Project 215571.02
15 May 2024
R.001.Rev0
MJJ

Additional Geotechnical Comment

Proposed Additions

Lot 108 DP1242013, Charlotte Pass NSW

west wing fire escape
[section view] scale 1:20 detail

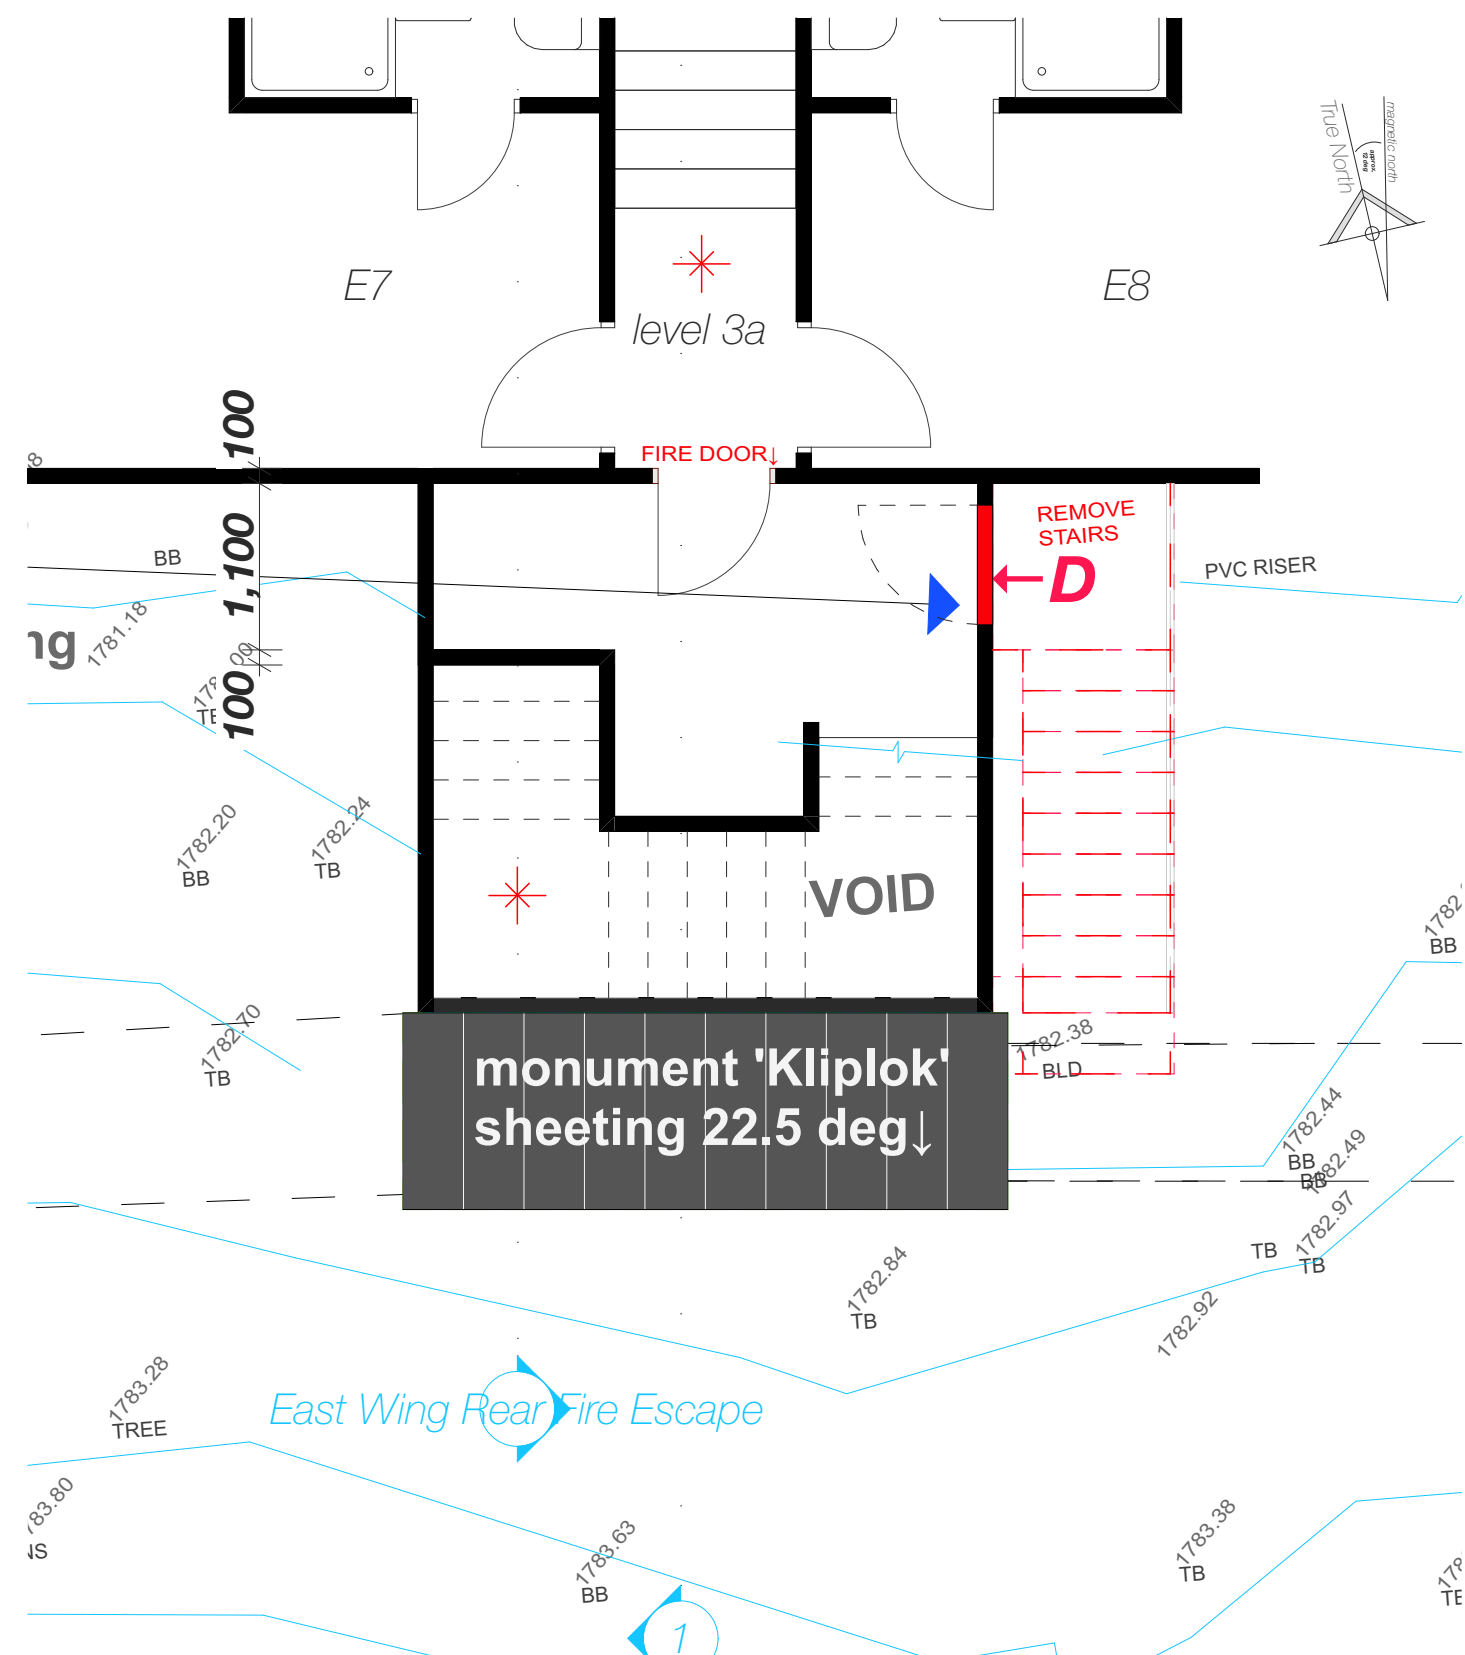
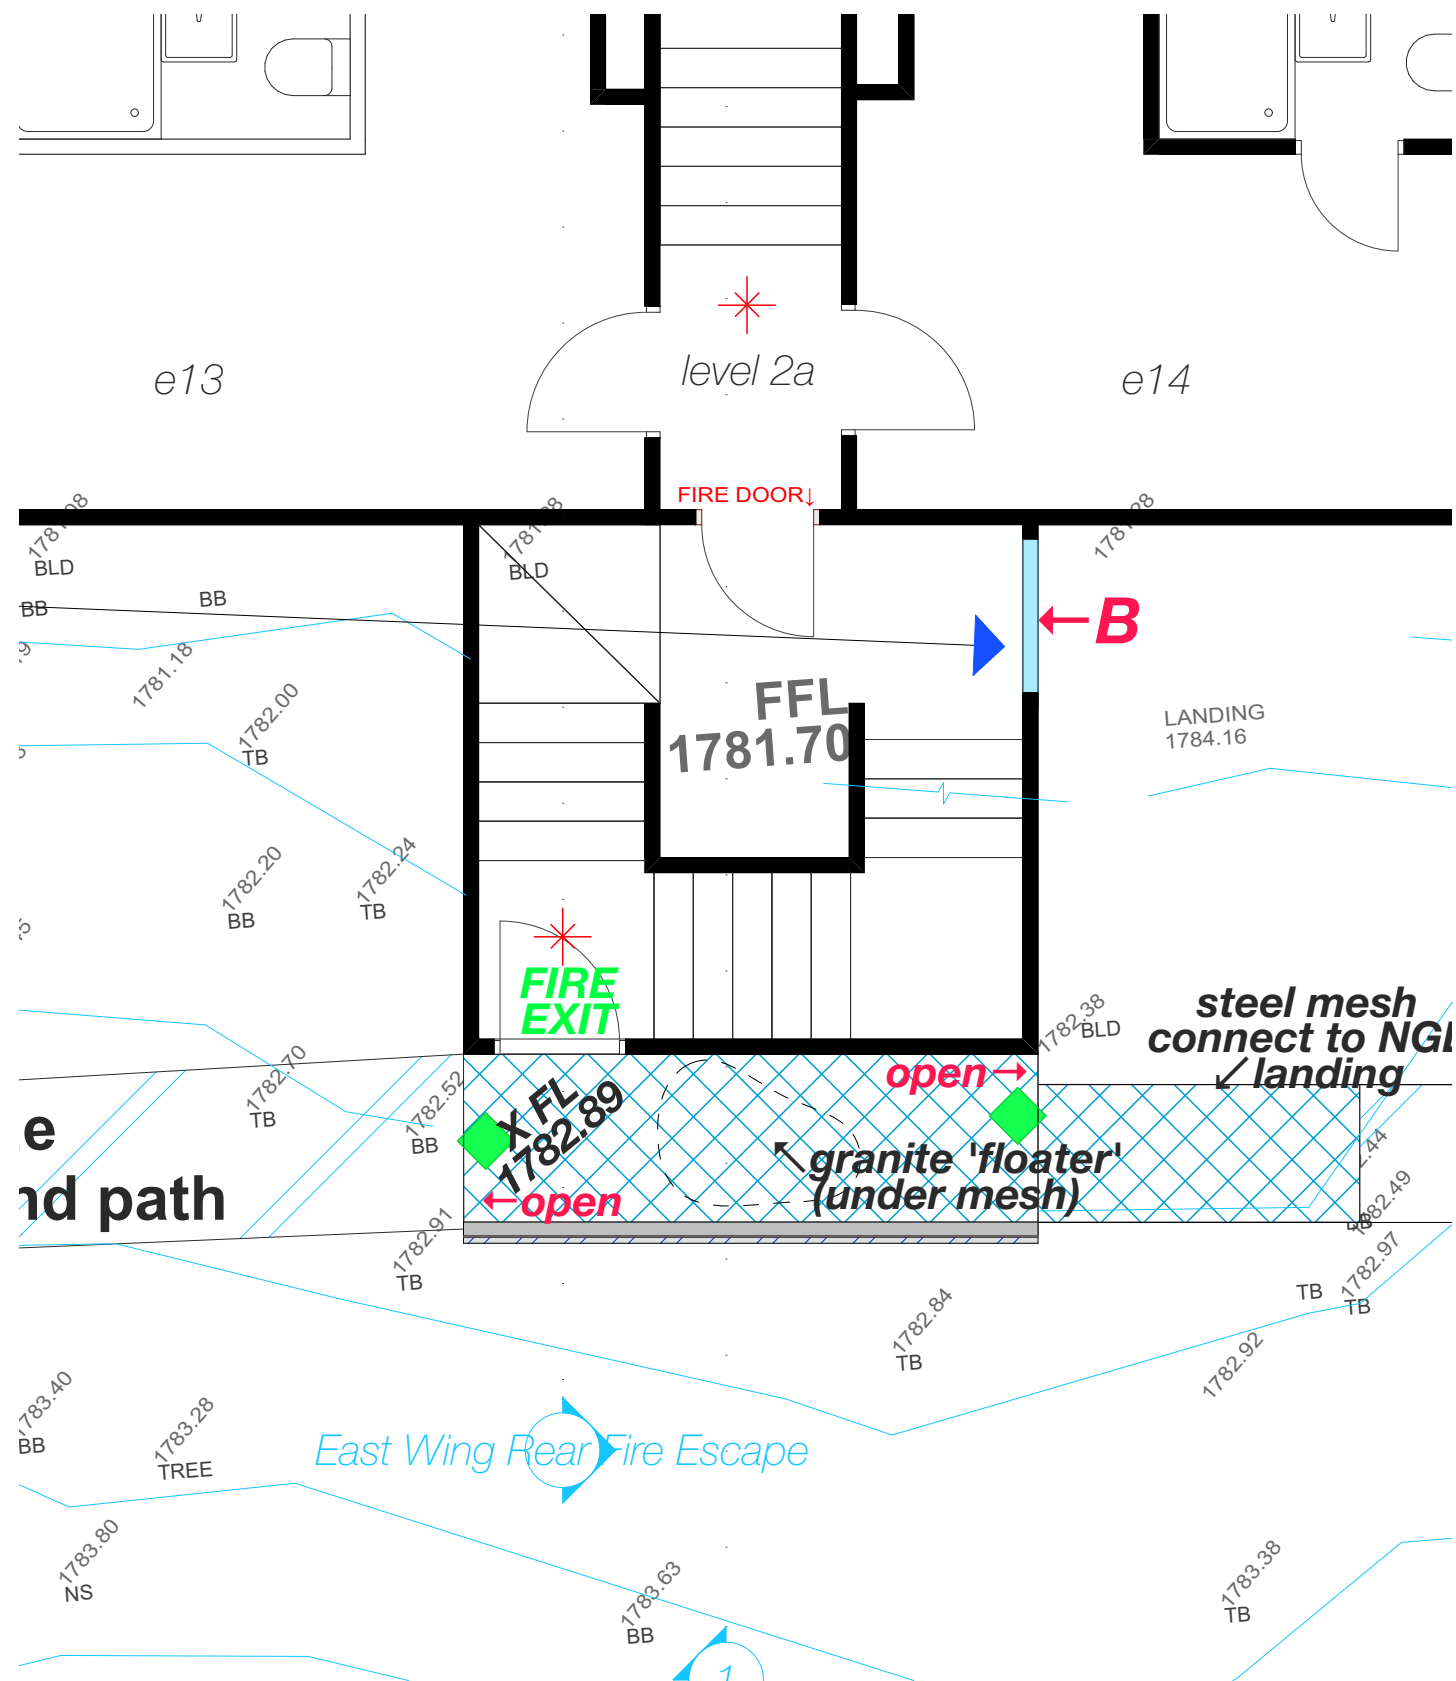
1. The front stairs are variable in terms of risers, especially on the lower timber section. It is understood that these stairs will be replaced with a single flight of galvanised steel treads.
2. The side exit stairs (fire escape route) required a more detailed plan and section.
3. Provision of an exit landing for the east kitchen.

For Items 1 and 2 above, given the location of these two areas are in steeper parts of the site, Douglas Partners Pty Ltd would recommend all footings found within weathered rock. This would be in accordance with our 22 July 2022 report (Project No 215571.00) for likely footing depth and allowable bearing pressure recommendations.
